37/03-04UU 7220 Spruce Ave
Takoma Park Historic District

7220 Spruce - before and after (second story addition to Contributing Resource)

HISTORIC PRESERVATION COMMISSION STAFF REPORT

PROPOSAL: Construction of 2nd-story addition

DESIGN D

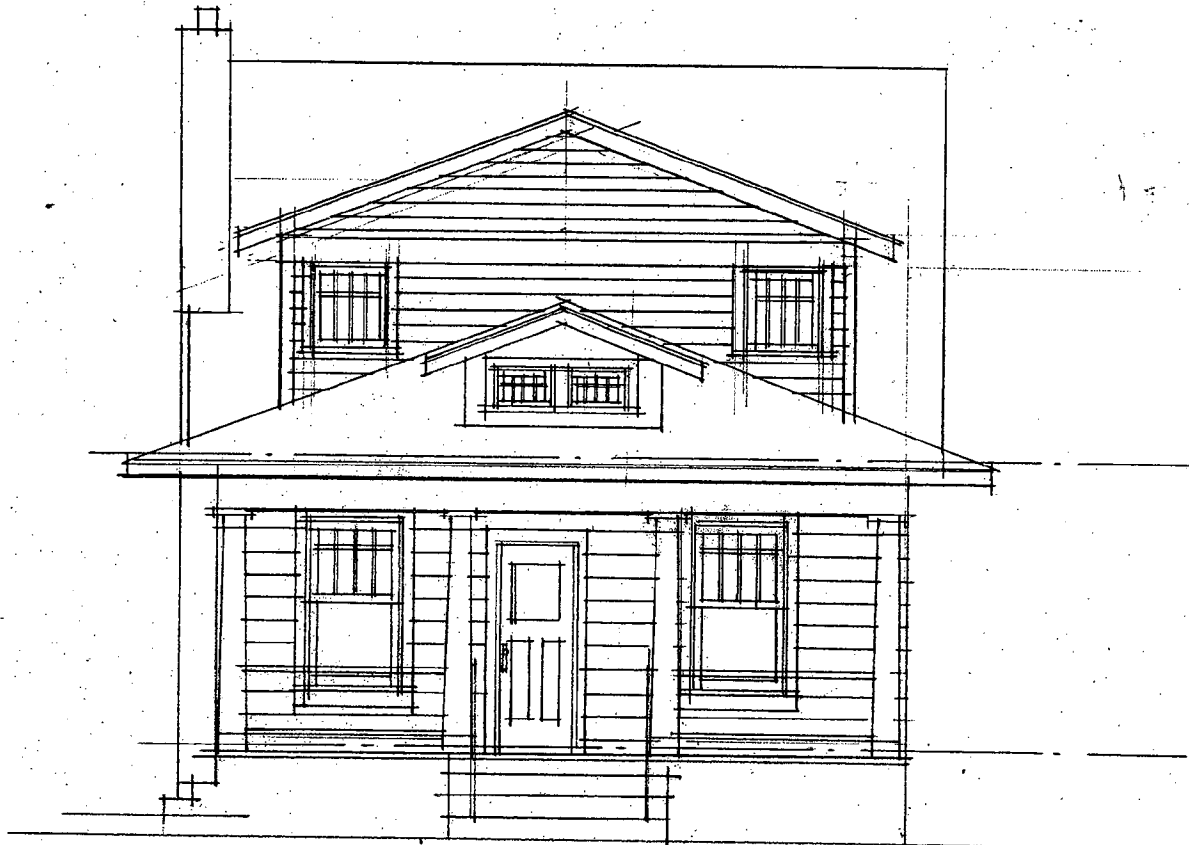
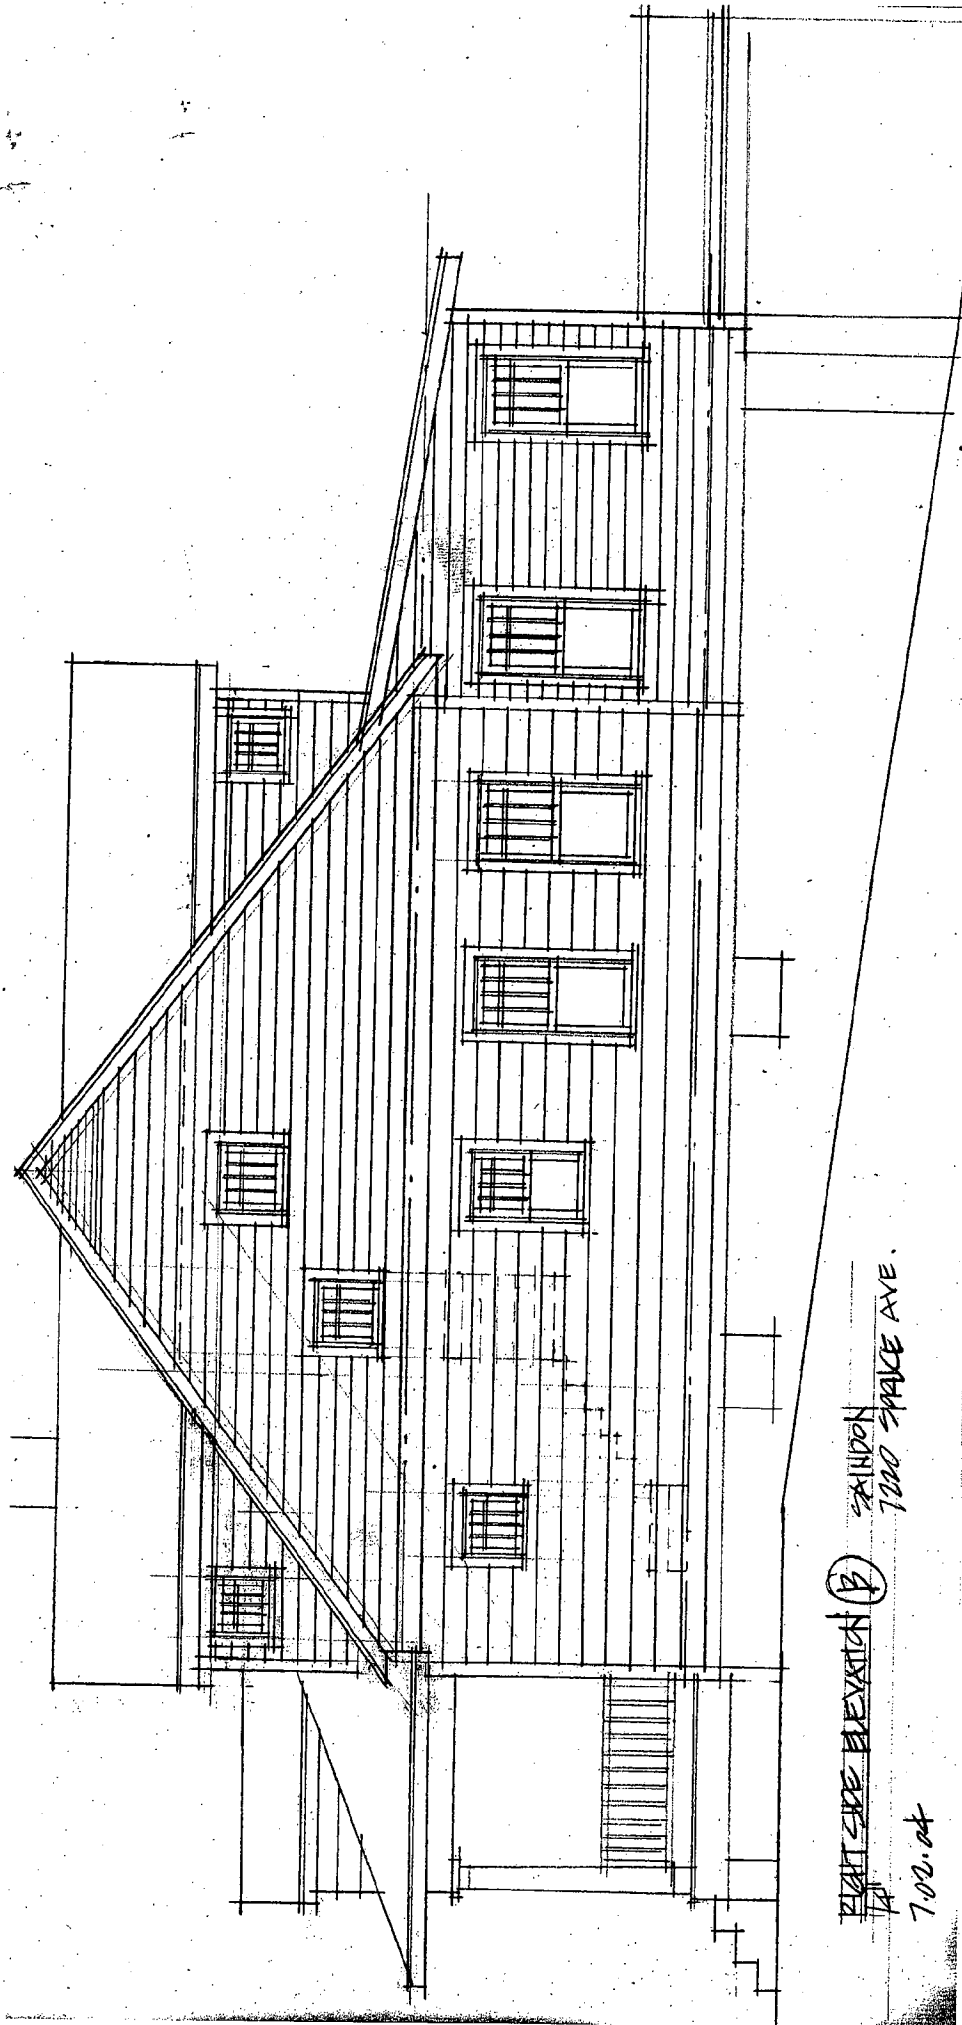
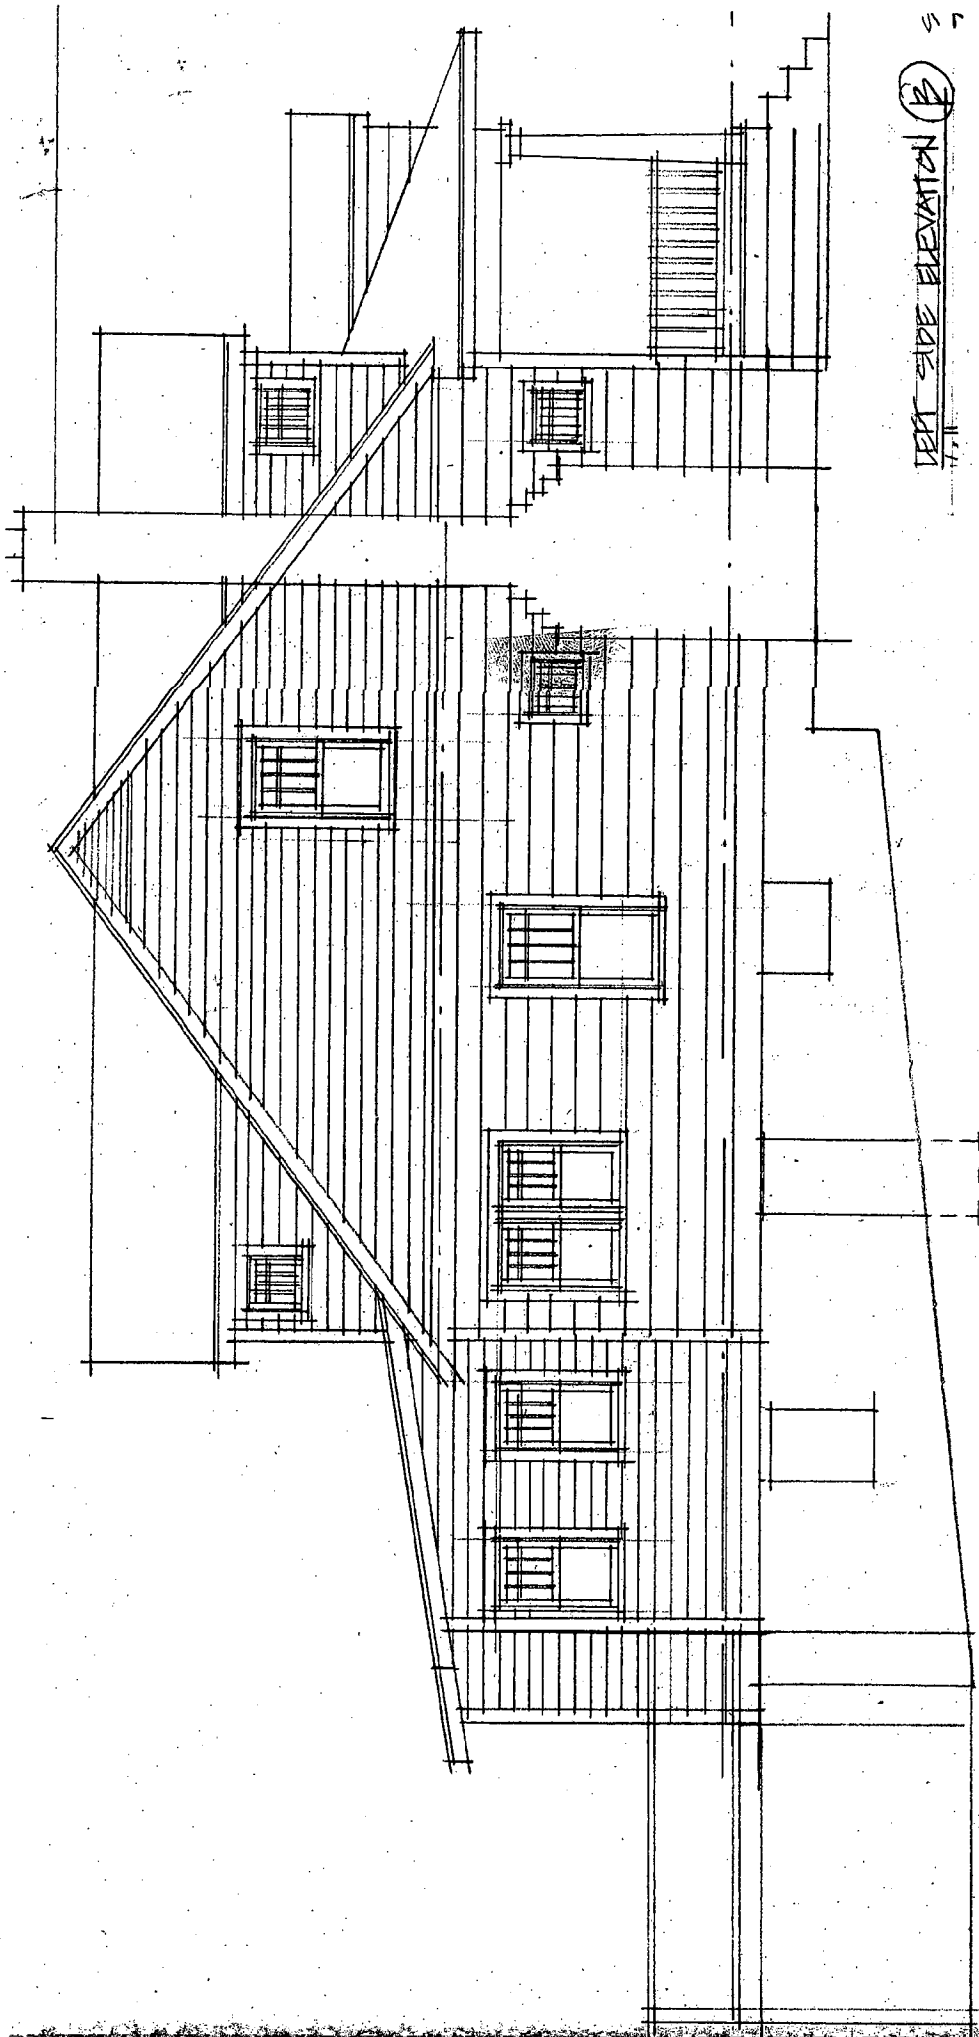
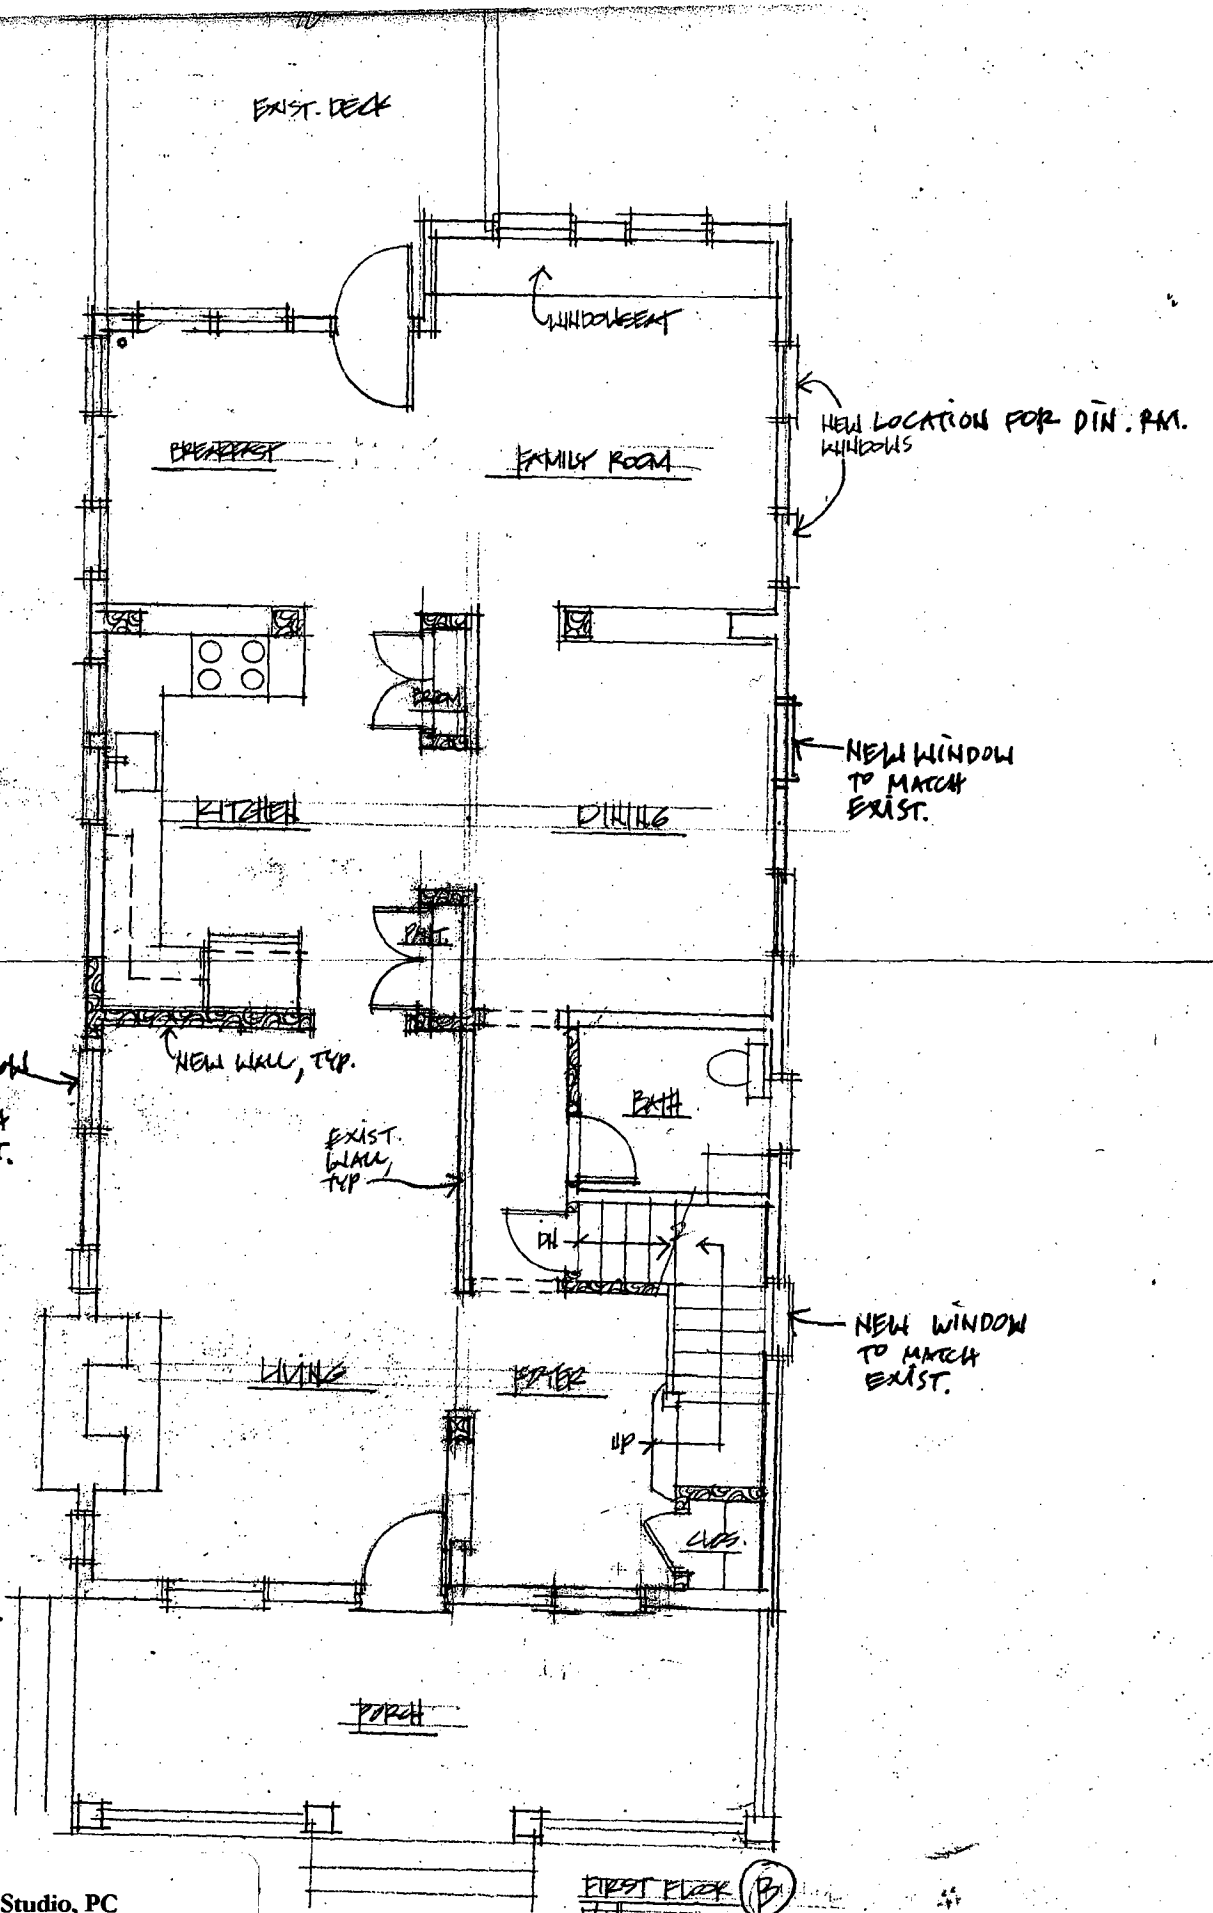
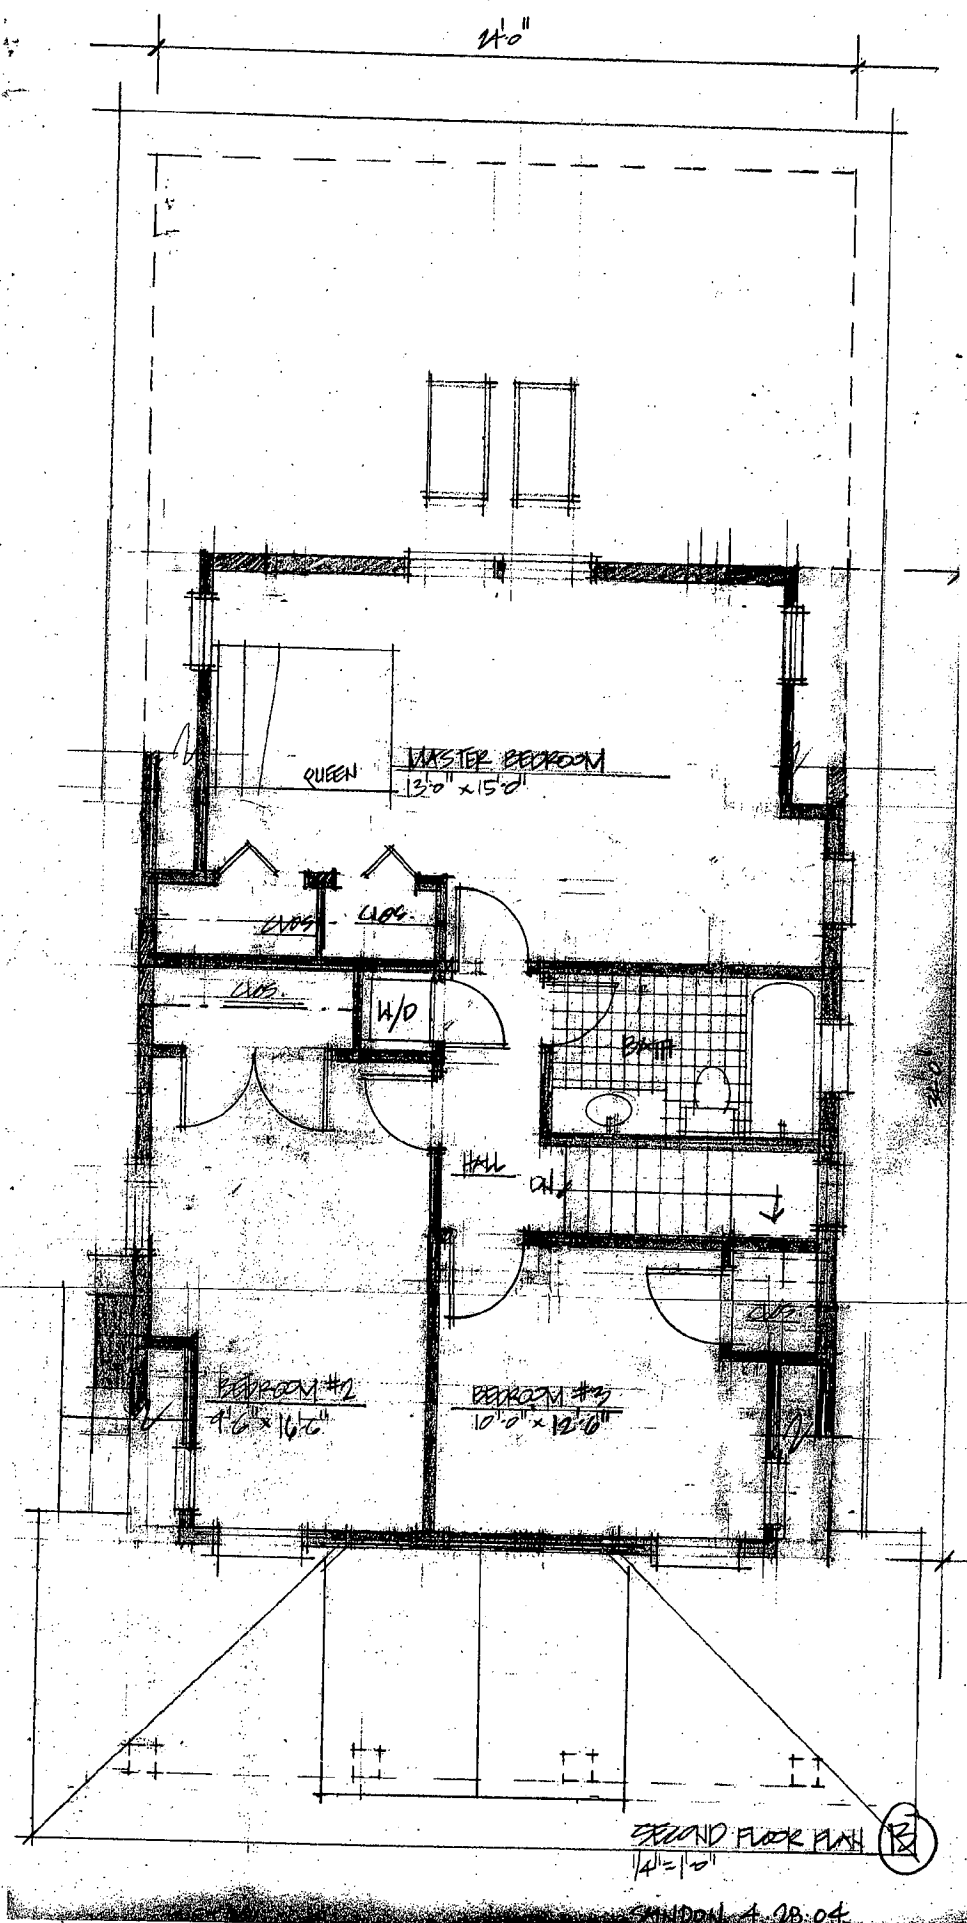
At the Preliminary Consultation, the applicant heard the HPC discuss the uniqueness of this bungalow's front elevation and hipped roof and the importance of the retention of those features. After the Preliminary, the applicant submitted Designs C and D, and staff finds Design D a more successful response to the HPC's concerns of the two designs.

In Design D, the applicants basically took their initial design and reconfigured it to retain the front of the house. They have kept the front elevation intact including the hip roof on the porch and the dormer and have also kept the front door in its original location, which the HPC requested, and then expanded up into a new gable roof with two dormers.

Staff finds that Design D has resolved the HPC's concerns about retaining the front of the house and meets the Takoma Park Guidelines. Should the HPC find this design approvable, staff will work with the applicant on appropriate materials including wood siding instead of Hardiplank, minimal original window removal, and, if necessary, relocation of original windows.
